COUNCIL AGENDA REPORT

SUBJECT: CONSIDER A REQUEST TO CHANGE THE ZONE FROM RM:5-12 TO RM:5-12:PD FOR A SEVEN LOT RESIDENTIAL SUBDIVISION AND APPROVAL TO DEMOLISH A SINGLE FAMILY RESIDENCE AND A 3-UNIT APARTMENT BUILDING BUILT PRIOR TO 1941. NO SIGNIFICANT ENVIRONMENTAL IMPACTS HAVE BEEN IDENTIFIED AND A MITIGATED NEGATIVE DECLARATION IS RECOMMENDED. APNS 529-16-021 AND 045. PLANNED DEVELOPMENT APPLICATION PD-05-1, ARCHITECTURE AND SITE APPLICATION S-05-15, NEGATIVE DECLARATION ND-05-03. PROPERTY LOCATION: 17005 AND 17017 ROBERTS ROAD. PROPERTY OWNER: KHURRAM IQBAL APPLICANT: LOUIE LEU ARCHITECTS

Location of Job: 17005 & 17017 Roberts Road, Los Gatos, PD-05-01, S-05-015, ND-05-03

**SITE PLAN
OPTION D**

OPTION C/D - AERIAL VIEW OF UNITS 1 & 2

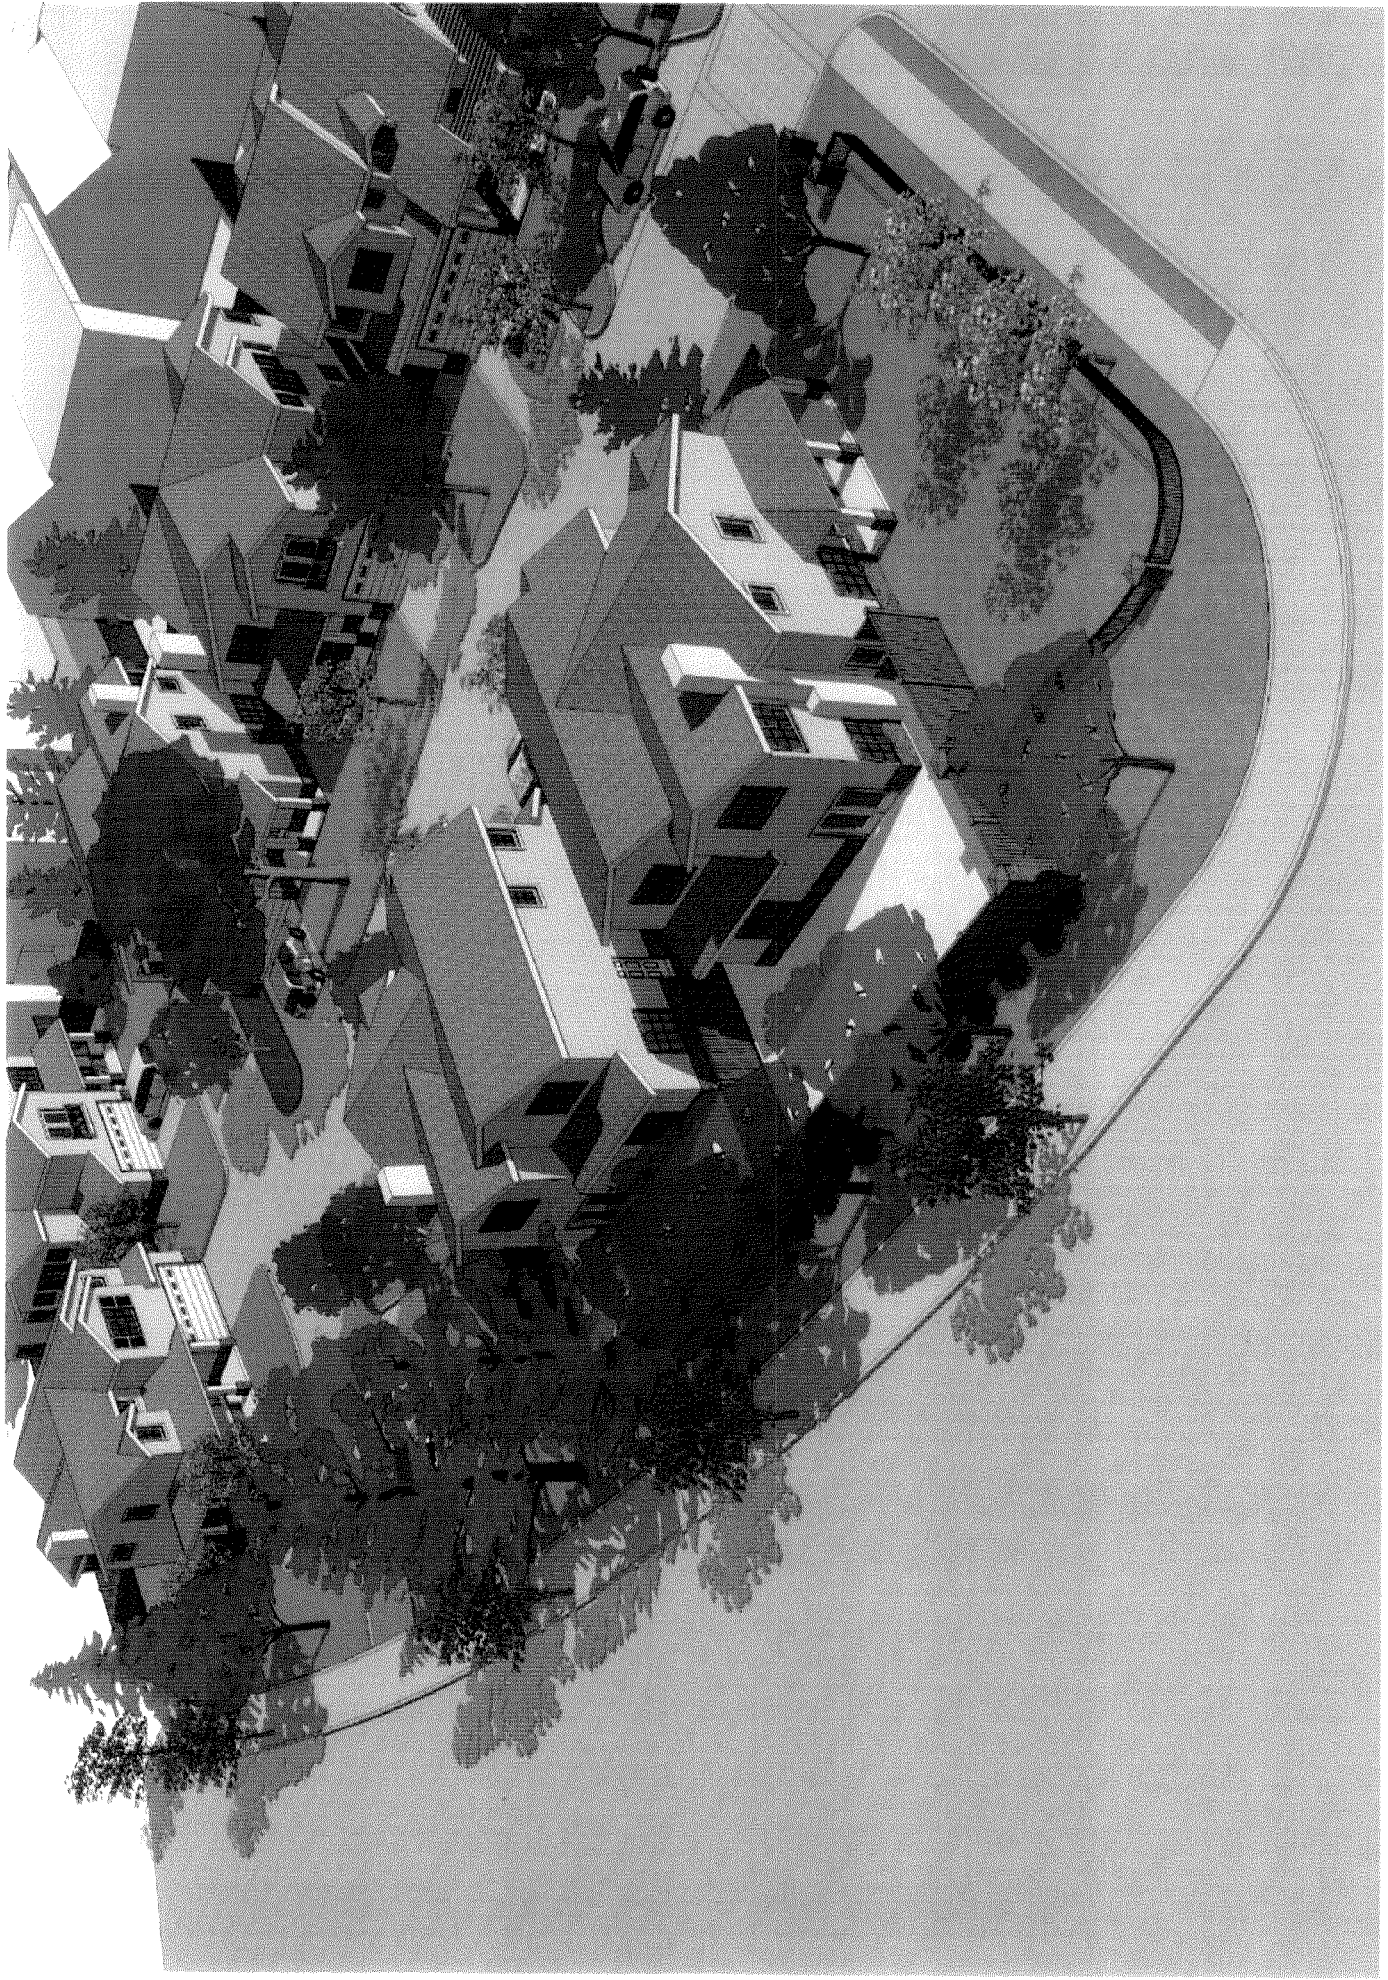
In addition, we did explore the possibility of turning units 1 and 2 such that the fronts of the units faced the private drive, as suggested by Council member Spector. This is shown in the plan labeled Option "E". We do not like this option however, as the rear yards are subject to more sound exposure from Blossom Hill Road, and the sound wall/fence would be approximately 90 feet in length, instead of 45 feet in the modified Option "C" or Option "D". It would also be located much closer to Blossom Hill Road, and to the existing mature pine trees. This would eliminate any possibility to install a two foot berm with a 6 foot fence. Instead, there would have to be an 8-foot sound wall/fence. We also considered just turning the units and leaving the yards as they were, but this would create side yards for the units instead of back yards and eliminate the appearance of front elevations and "eyes on the street" on the Blossom Hill Road side. For these reasons, the original orientation of Units 1 and 2, with the rear yards facing each other and the reduced length and height of the sound wall/fence is the better option.

We have included 3d simulated views showing the difference between the orientation of the units and fence locations of Option "C/D" and Option "E". To illustrate how the fence might appear, we have also included literature on precast concrete fences that have a more natural wood appearance, which is similar to what we are proposing.
